PRODUCT CHANGE NOTIFICATION

#PCN-DCT-H5L4-10

| Business Unit | Product Line Code | Type of Change | Action | Date of issue |
|---------------|-------------------|----------------|-------------------------------|---------------|
| DCT | 254 | Mechanical | Notify Distributors and Field | 07/08/2010 |

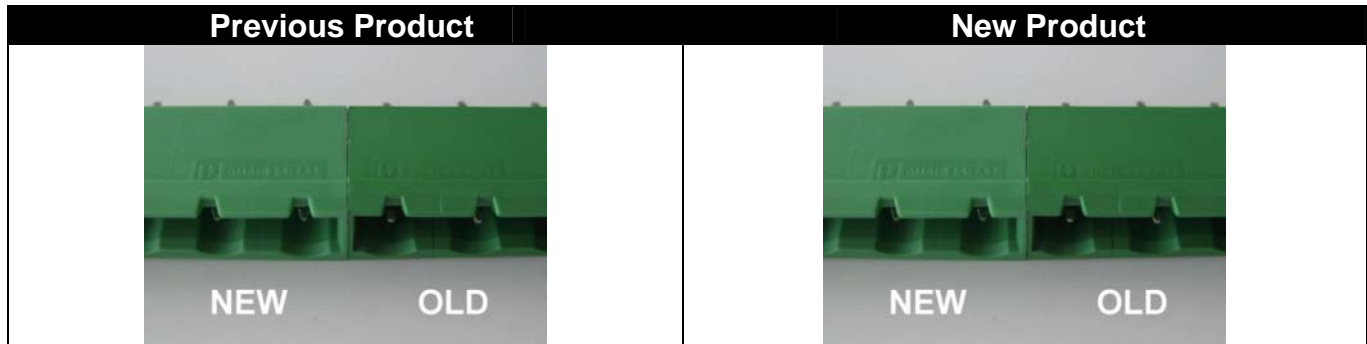
For the following products, the headers and plugs will undergo a slight color adjustment. This change is occurring to ensure a clearer visual assignment of the headers and plugs. This modification will change the insulation material group improving from PBT to polyamide (PA) as the new insulation material. All other technical data is not affected by the change.
